Re: **ADDENDUM SEVEN - DELAWARE STATE POLICE - TROOP 3- BID PACK 1**
Dover, Delaware
2011116.00

ADDENDUM SEVEN

The addendum forms a part of the contract documents and modifies the original bidding documents dated, October 9, 2013, modified by Addendum No. 1 dated 10-18-2013, Addendum No. 2 dated 10-25-2013, Addendum No. 3 dated 10-31-2013, Addendum No. 4 dated 11-08-2013, Addendum No. 5 dated 11-11-2013, and addendum No. 6 dated 11-16-2013, as noted below.

1 / E-XX PART SITE PLAN – ELECTRICAL POWER
SCALE: 1/16"=1'-0"

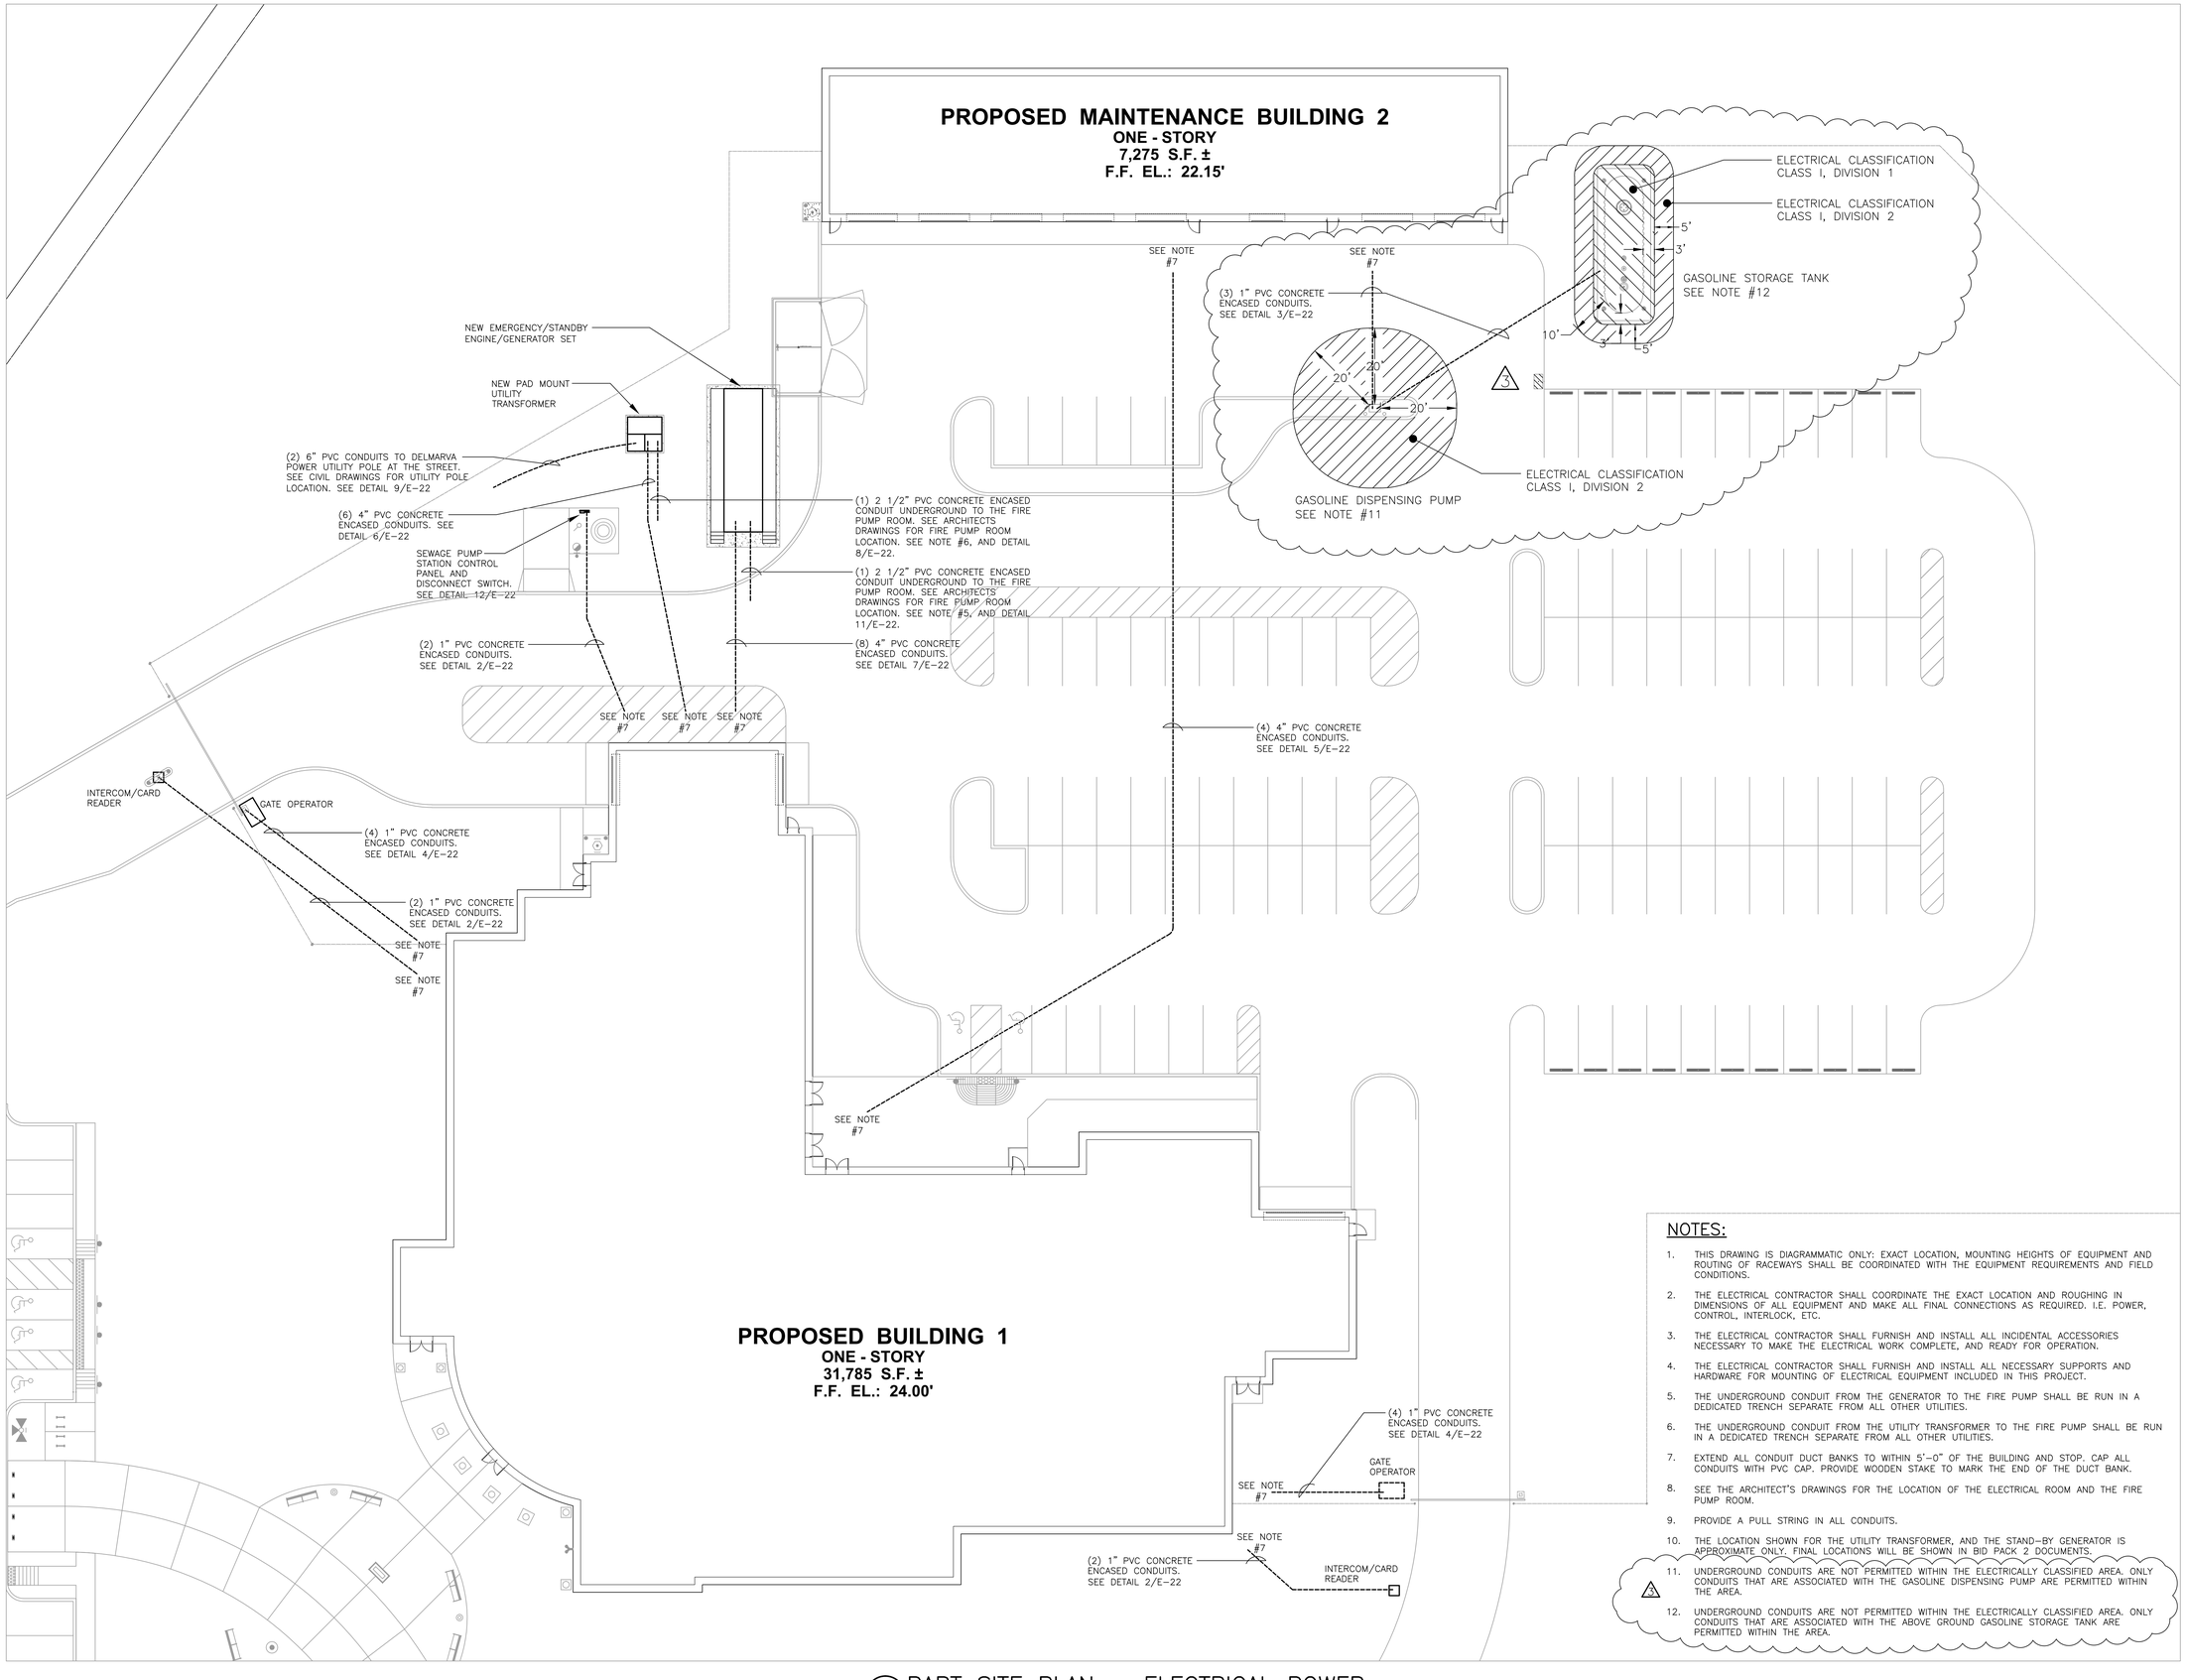
d. Added general notes #8 and #9.
5. Sheet E-21 (Revised Sheet Reissued, see clouded revisions)
    a. Identified the electrical classification areas around the gasoline dispensing pump, and the above ground gasoline storage tank.

b. Added general notes #11 and #12.
